# Bluefish Hydro Comprehensive Dam Safety Review

Northwest Territories Power Corporation  
January 2017  
Project: 159100263

Final Report

Prepared by:  
Stantec Consulting Ltd.

Figure 4-8: Discharge coefficient using NTPC dataset

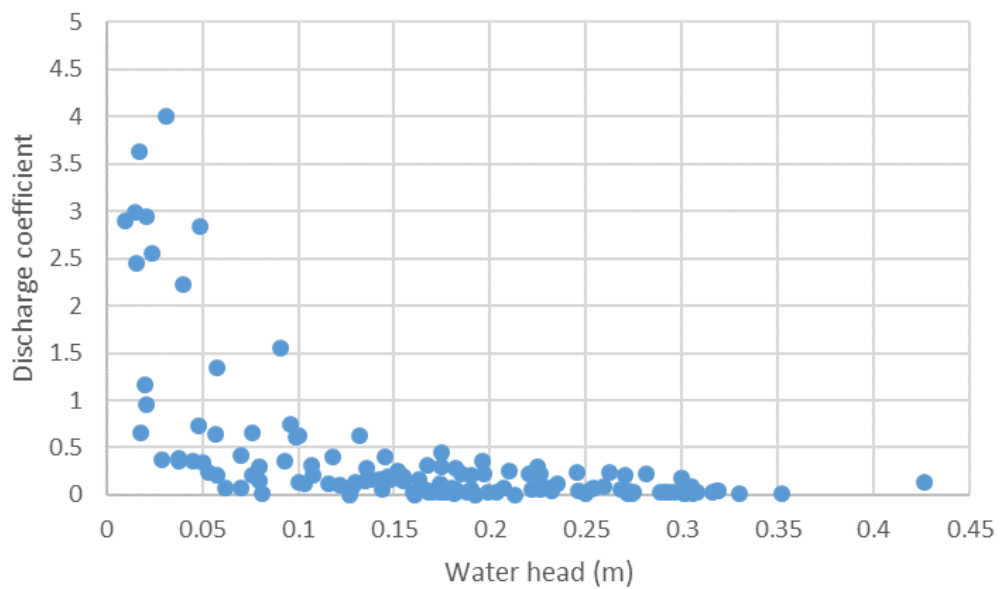
The discharge coefficient used in the spillway design is around 1,705 for a broad crested spillway. The values that were found in this analysis are too low compared to the theoretical design value of 1,705. Using the computed value of 0.941 for the discharge coefficient would under estimate the flow for a given head (for certain heads, the computed flows would be very low). Almost no high flows were measured at Bluefish dam after the commissioning of the dam; i.e. it is important to monitor and taking measurements of water level in the lake, downstream flow, IFR flow and plant flows when high flow occurs in the future (eventually hourly measurement). These measurements can later be used to calibrate a discharge coefficient using higher flow rates. Table 4-4 below present a comparison for different calculation of discharge coefficients.

Section reference	Issue	Recommendations	Priority rating
4.3.1.2.6	Discharge coefficient of spillway is not calibrated	Take measurements when high flows occur over the spillway of water level in the lake, downstream flow, IFR flow and plant flows (eventually hourly measurement).	L

**Figure 4-9: Bluefish water levels versus flows over spillway**

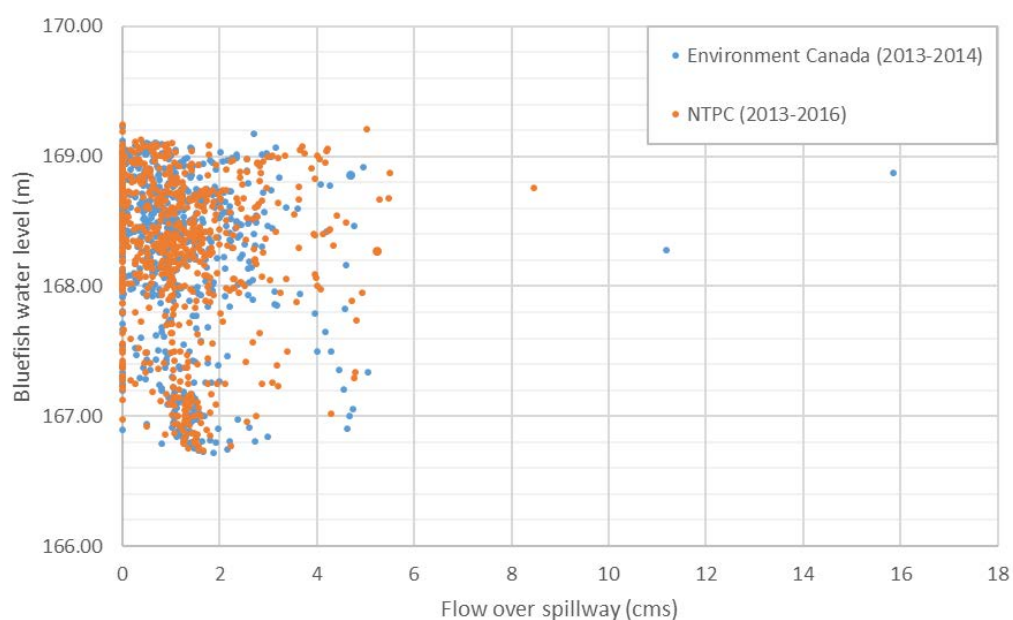
Figure 4-9 shows no clear relation between Bluefish water levels and spillway flows, so no relationship can be established using these data.
